Volume II
of the
Final EIS/EIR for the
Van Ness Avenue BRT Project

Appendices I & J

Response to Comments

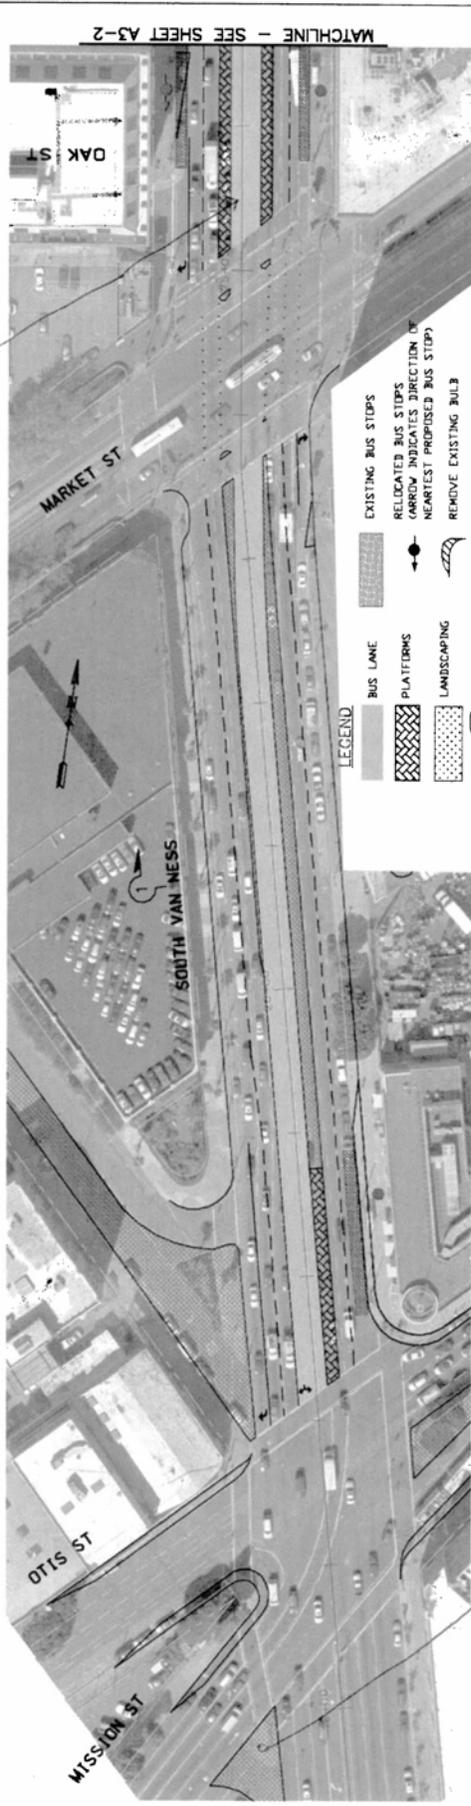
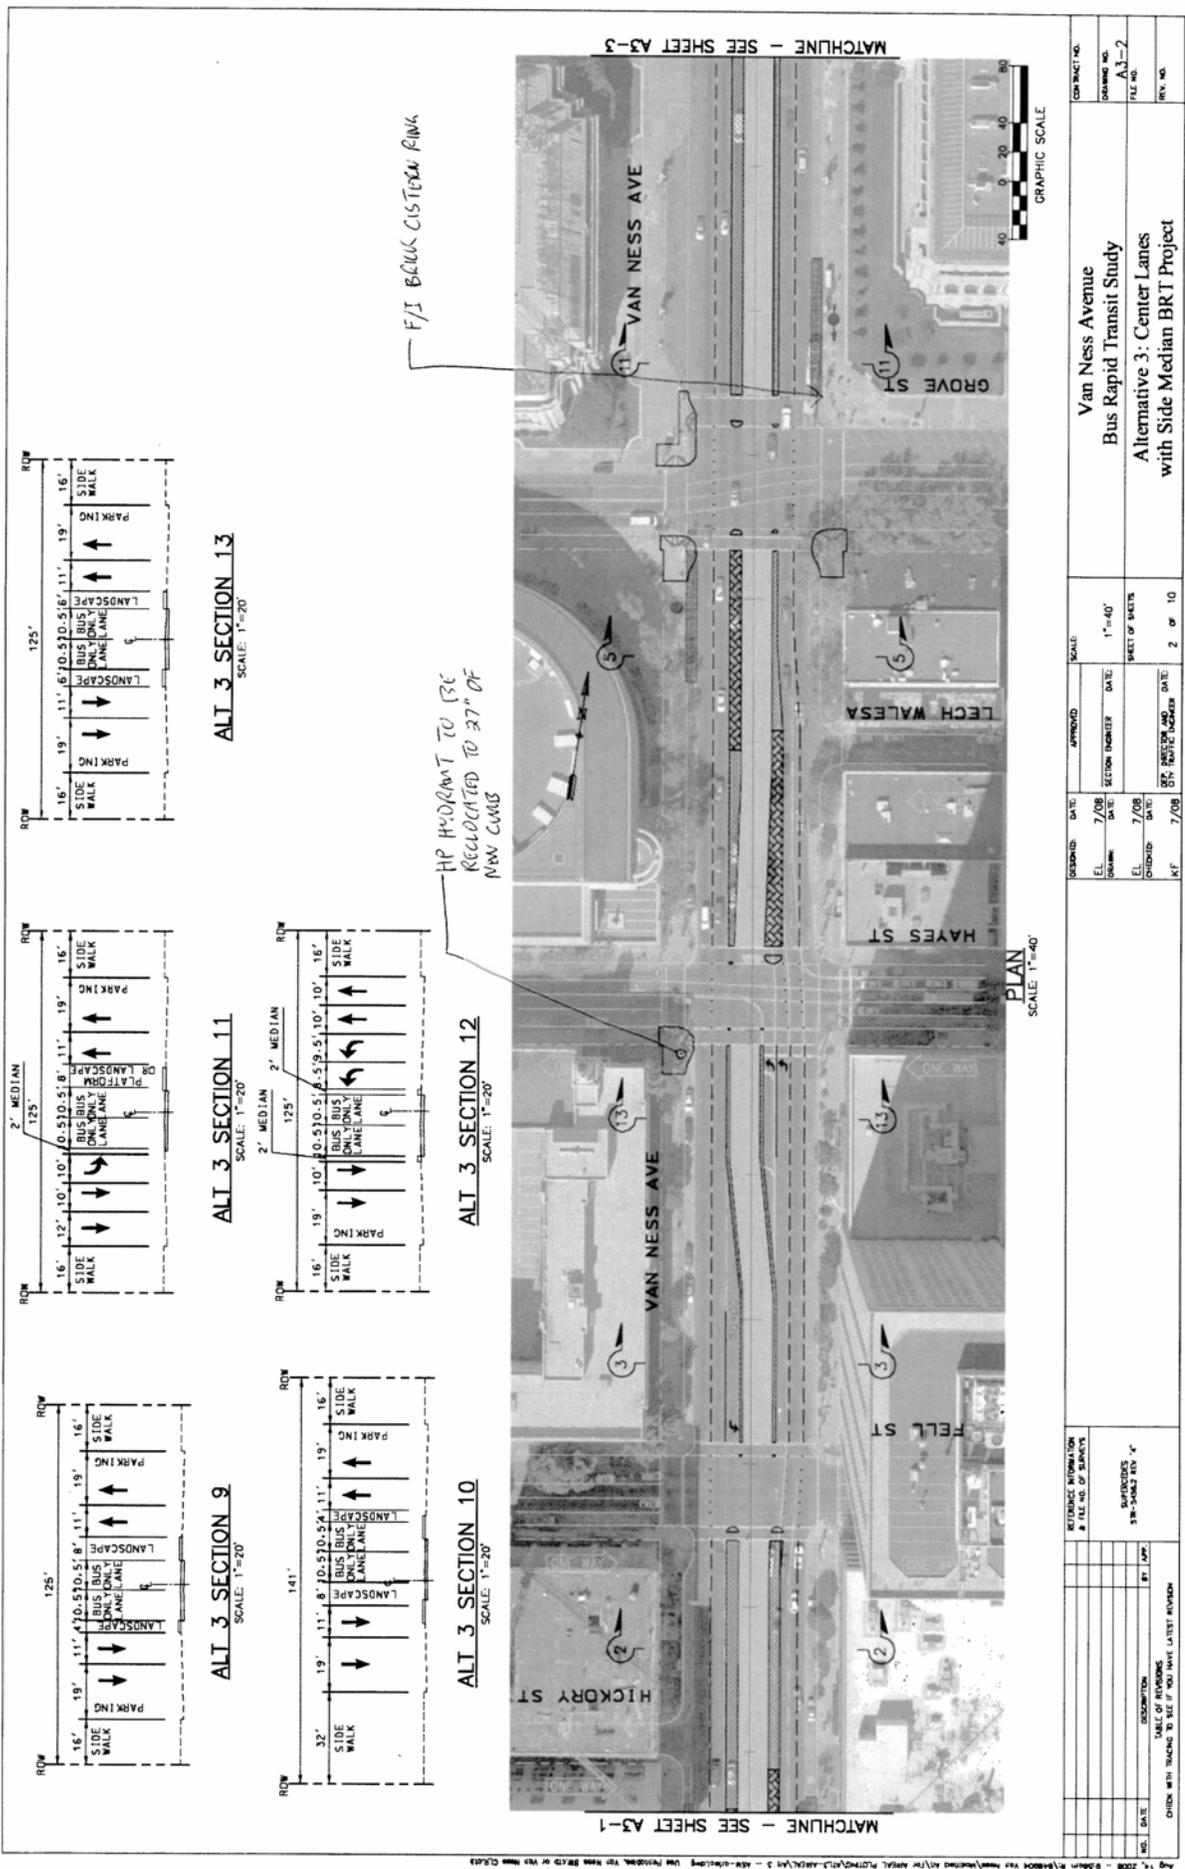
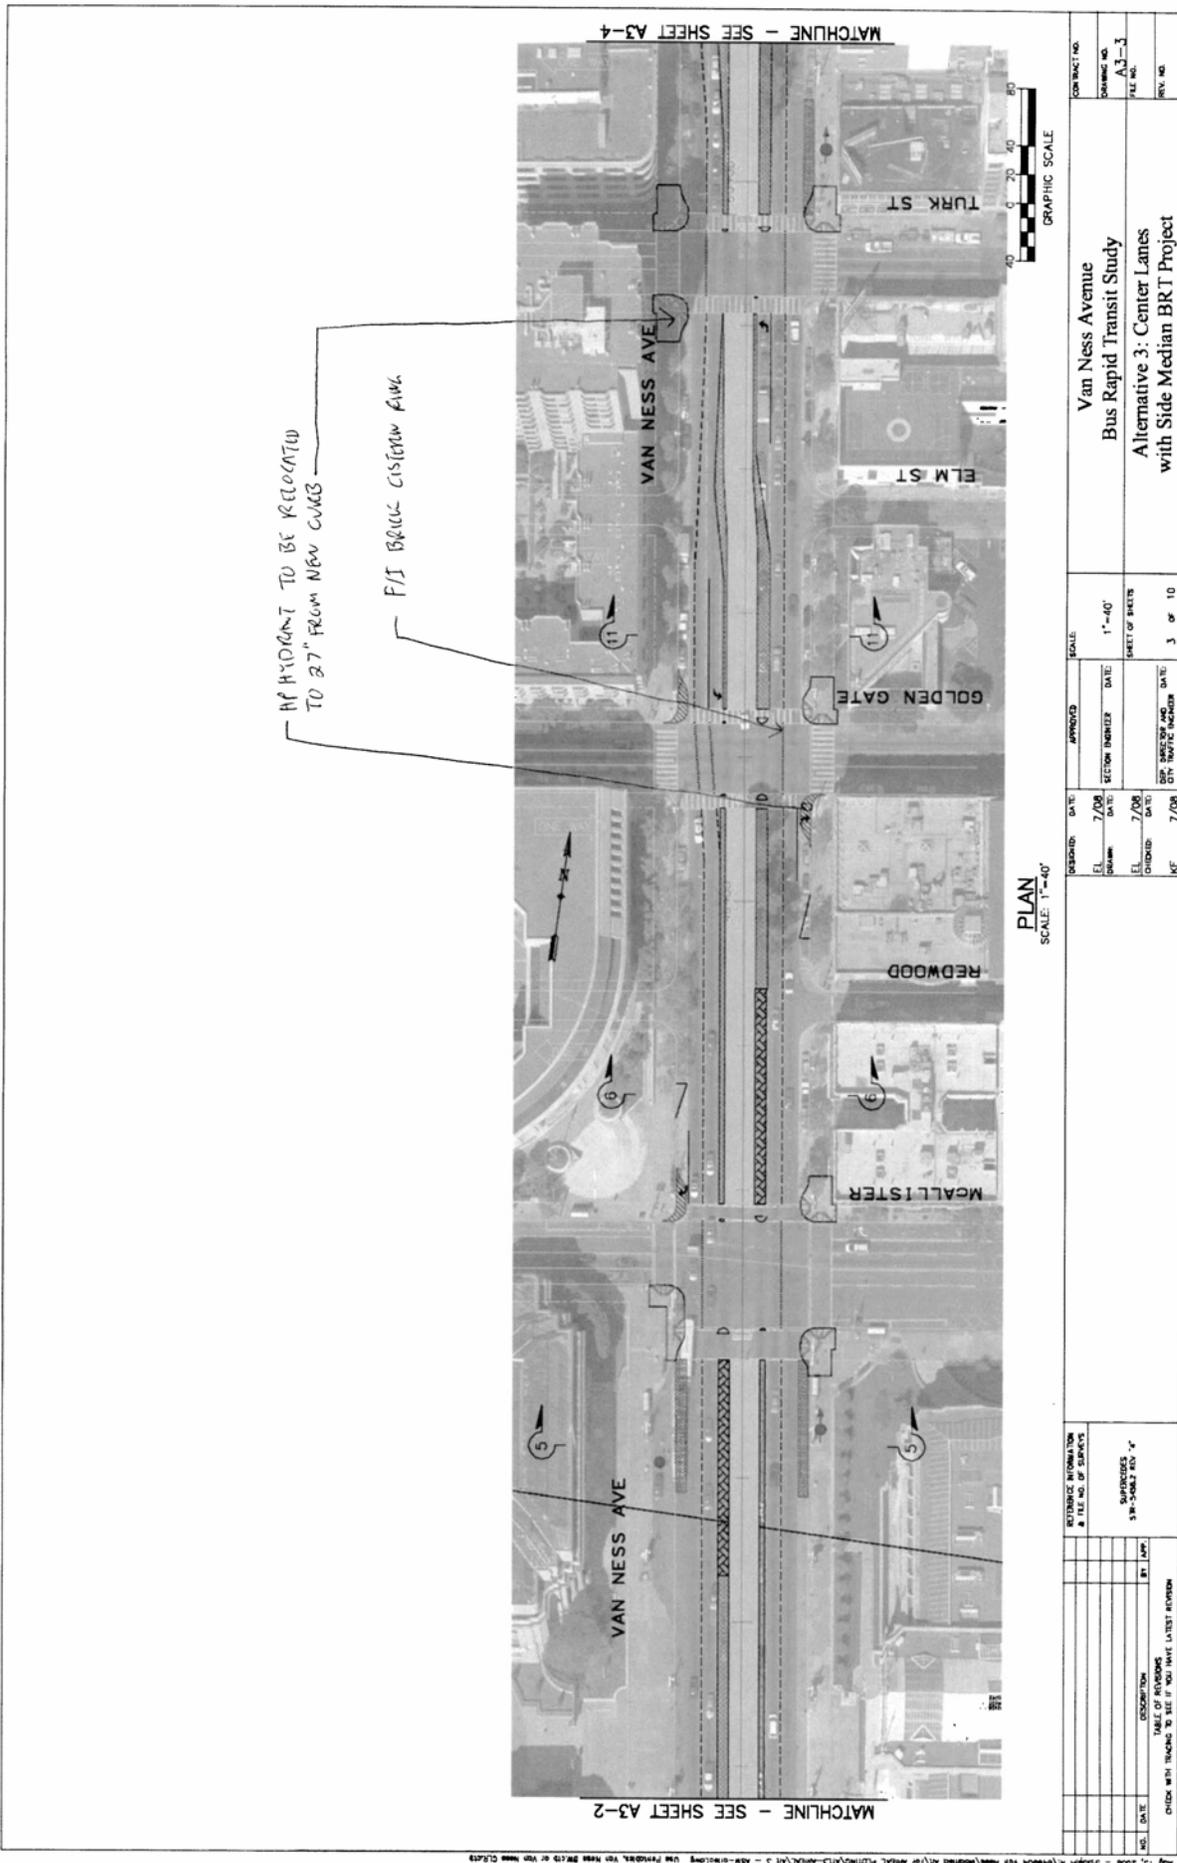
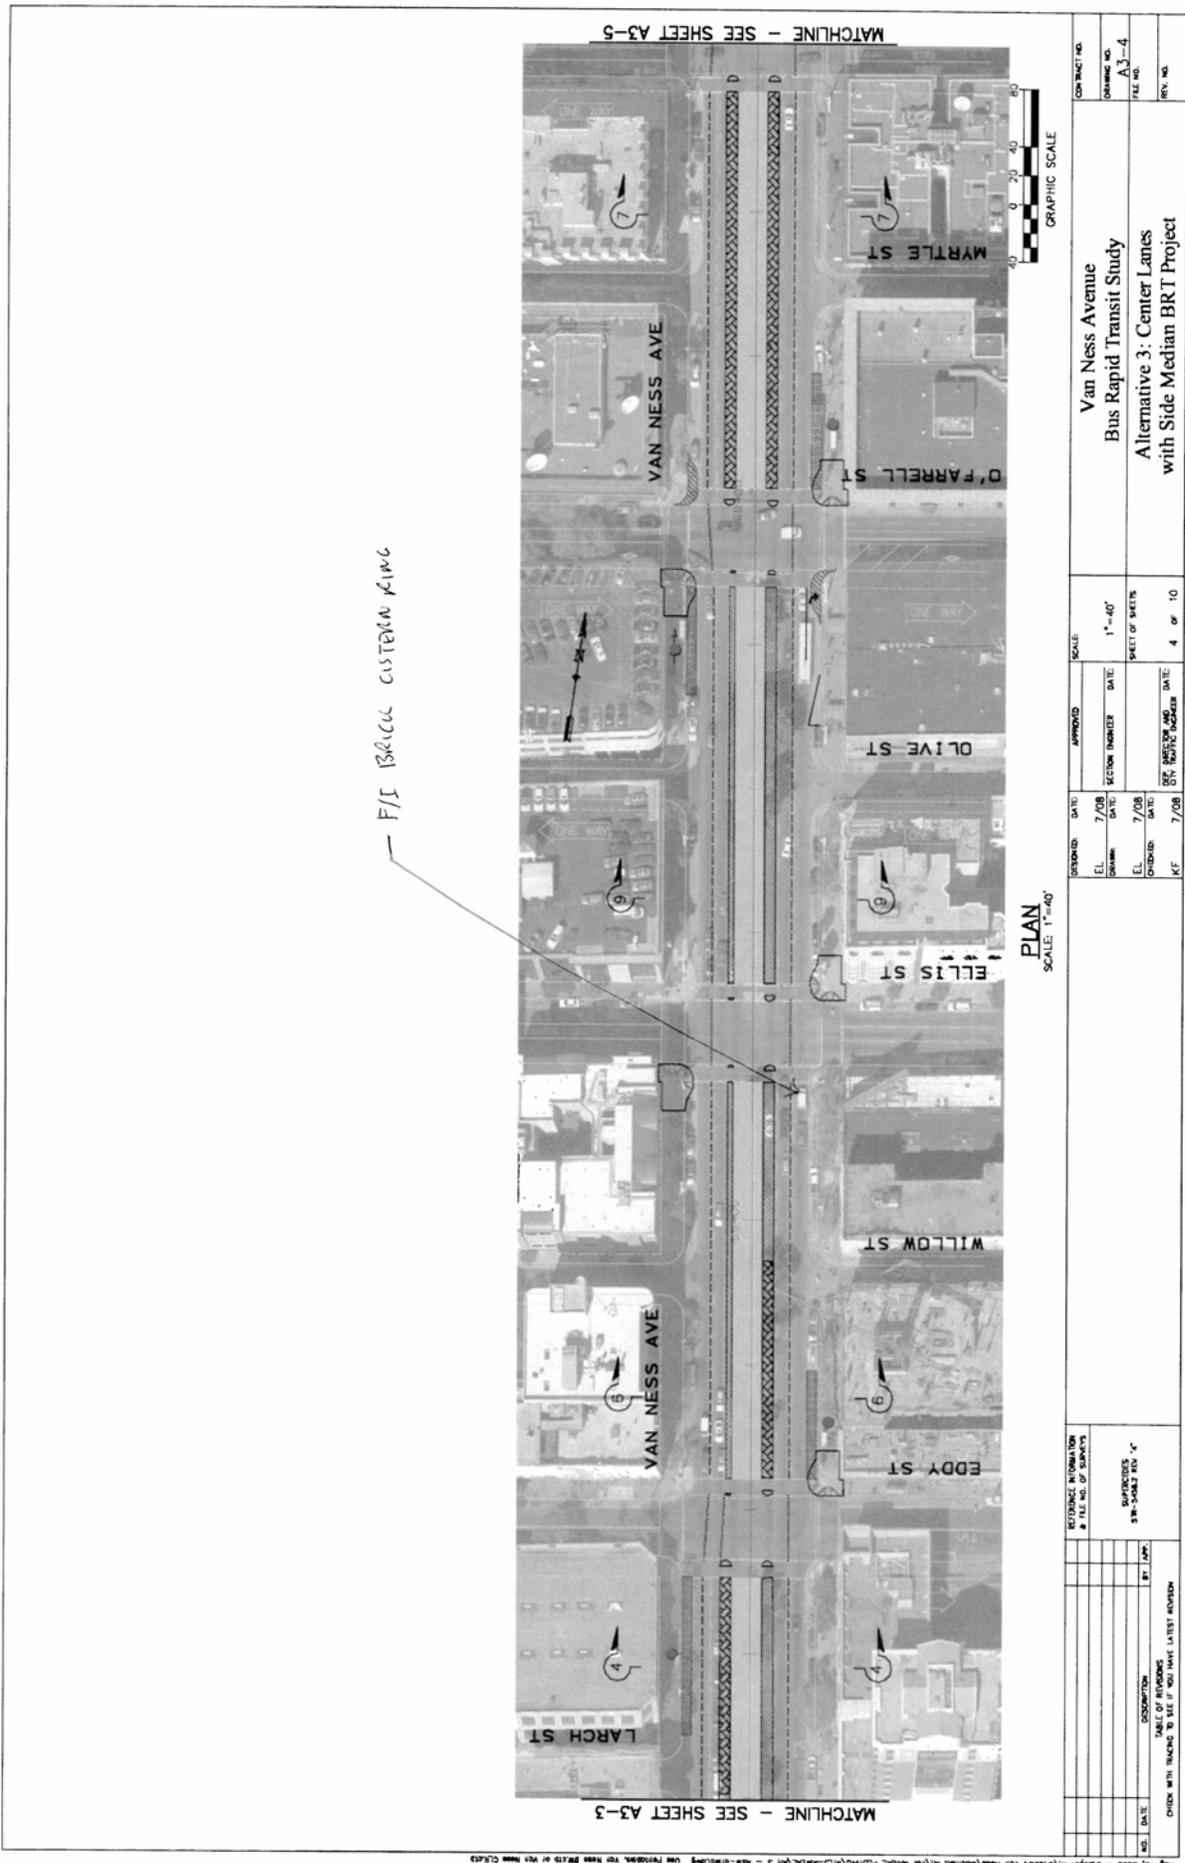
A-7e-60
continued

F/I BRICK CISTERN COVERS
RAISE CISTERN COVERS

HP HYDRA-MT TO BE
RELOCATED TO 37' FROM
NEW CURBS

F/S NEW CYCLIC CISTERNA RING
